Blossom Completeness Response

22-123981-PLN

3480 Blossom Drive NE Salem, OR 97305

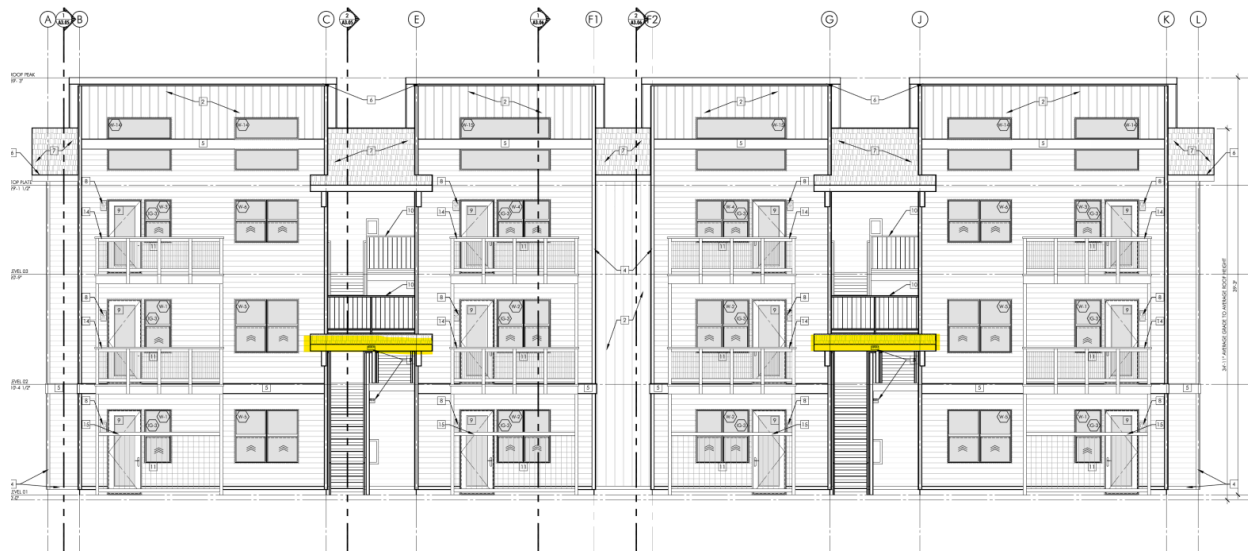
- d. No pedestrian paths through landscape planters.

- Pursuant to SRC 702.020(d)(1), landscaped planter bays provided will need to be at least a minimum of nine feet in width, and physically and visually separated to prevent the appearance of continuous pavement. Currently, the proposal does not meet these standards, and bays around the common open space in the center are less than the minimum width standard, likely as a result of the pedestrian walkways crossing through those areas. Pedestrian walkways split the bay, since walkways are not landscaping; the applicant will either widen or redirect the pedestrian walkways to conform to this standard.

Applicant's Findings: The applicant was attempting to provide additional landscaping and additional protection for pedestrians. This was achieved by adding the additional planters and plantings adjacent to the pedestrian paths. However, to conform with staff's request, the additional planters and landscaping have been eliminated as demonstrated on the revised site plan provided. This item is resolved.

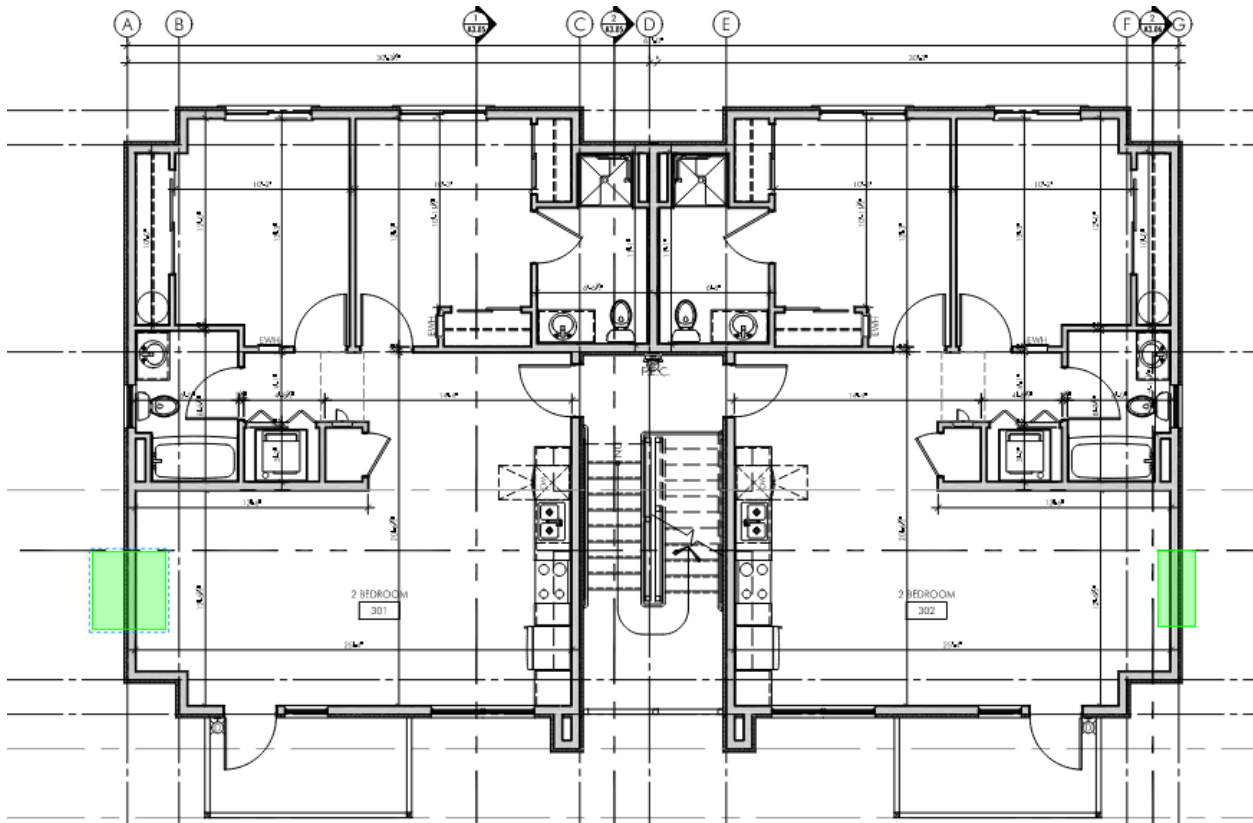
- (2) Design review standards for multiple family development with thirteen or more units. Please include the additional information on your site plan materials:
 - Pursuant to SRC 702.020(c)(1), all walls facing open space, parking areas and pedestrian paths shall have a window in habitable rooms. Bedrooms are habitable, which include closets. I have provided an attachment with window locations.

Applicant's Findings: The applicant is seeking an adjustment to this standard for some habitable rooms. This item is resolved.

Adjustment 1: The criterion to be adjusted is Salem Revised Code Section 702.020(c)(1) which states: Windows shall be provided in all habitable rooms, other than bathrooms, on each wall that faces common open space, parking areas, and pedestrian paths to encourage visual surveillance of such areas and minimize the appearance of building bulk.

Staff clarified in the completeness review that walls with closets are still subject to the requirements of windows for surveillance. In some instances, the applicant is seeking an adjustment to these standards for either electrical equipment placement on the exterior wall, or walls where closets exist. The end two-bedroom units don't have windows out of the back of the bedrooms because of the need for a closet. (Bldgs. B, C, E, F, G, H, J). Ground floor units on the two-bedroom units don't have windows on one exterior wall because of riser/electrical spaces. (Bldgs. B, C, E, F, G, H, J). Three-bedroom end units don't have windows out of the front bedrooms because of closets, and/or riser/electrical on ground floor. (Bldgs. A, D). All of these instances refer to the short end of the buildings. The other exterior walls of these spaces all have windows.

The applicant understands the purpose of this standard is to encourage surveillance of the grounds to increase safety. The applicant has demonstrated all common open spaces, pedestrian paths, and parking areas have windows from all directions facing toward them, meeting the intent of this standard.

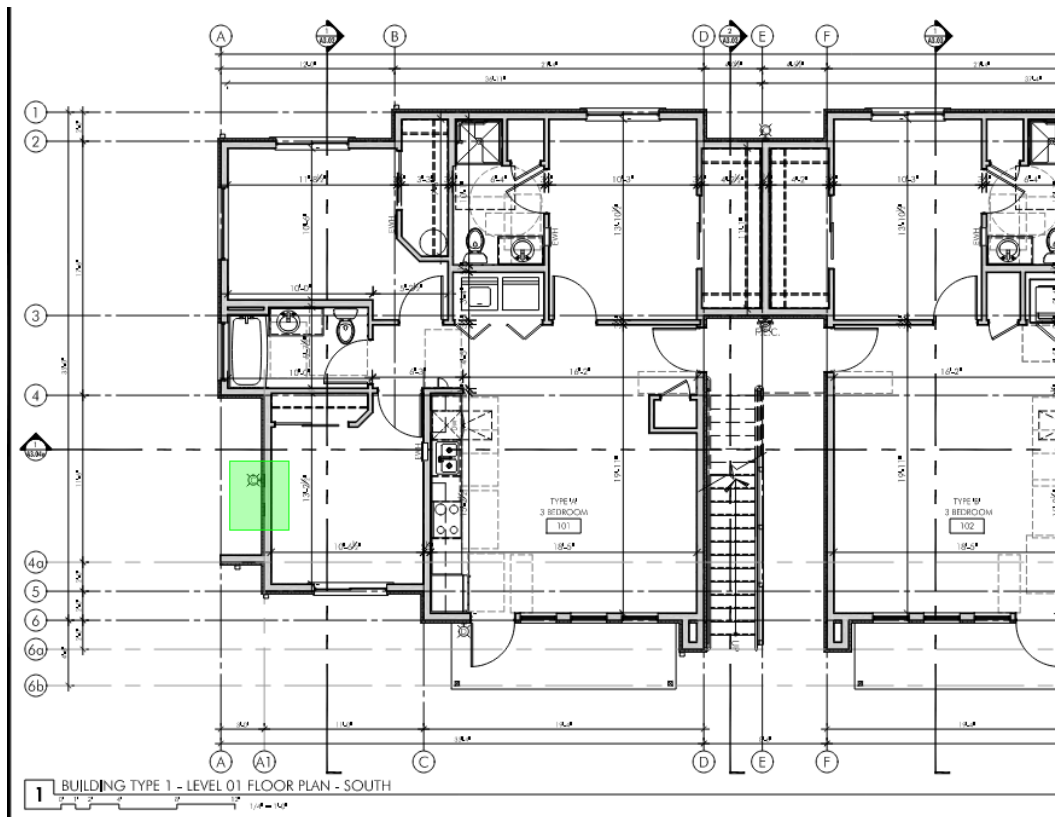
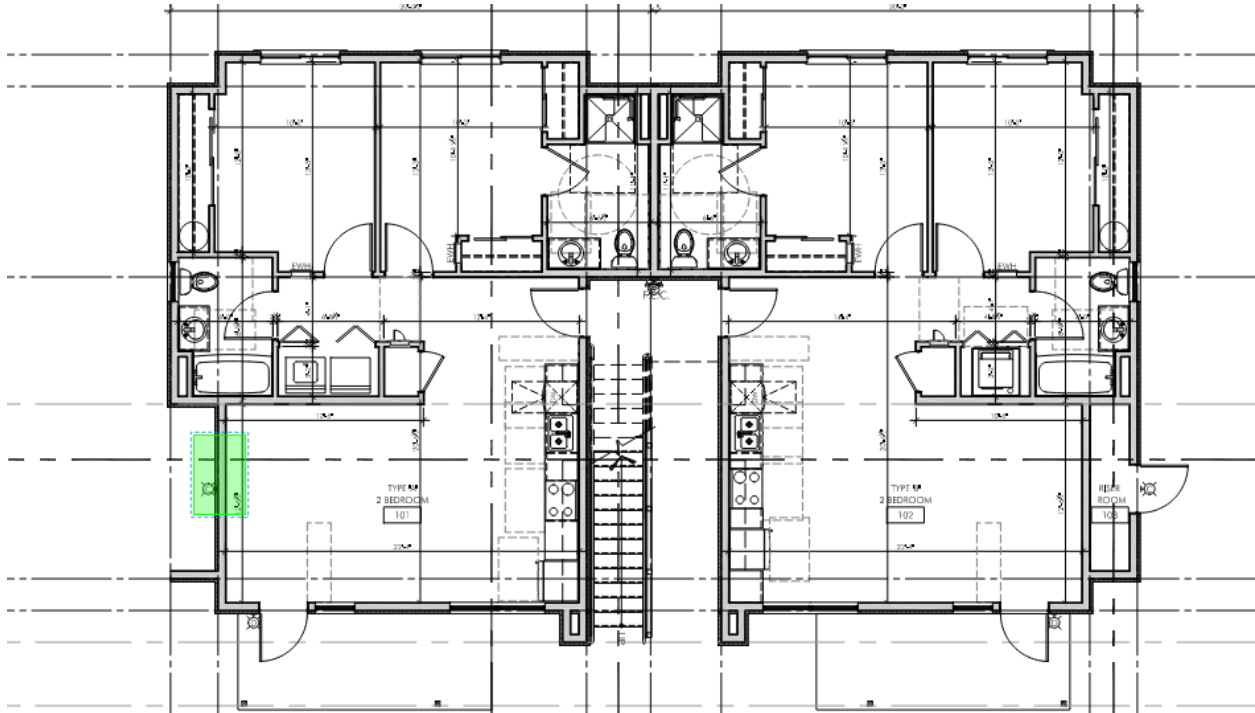
- (3) Missing Window. The applicant will need to revise the submitted floor plans to include windows on each wall of each room. These area's have been highlighted in green to provide further illustration.
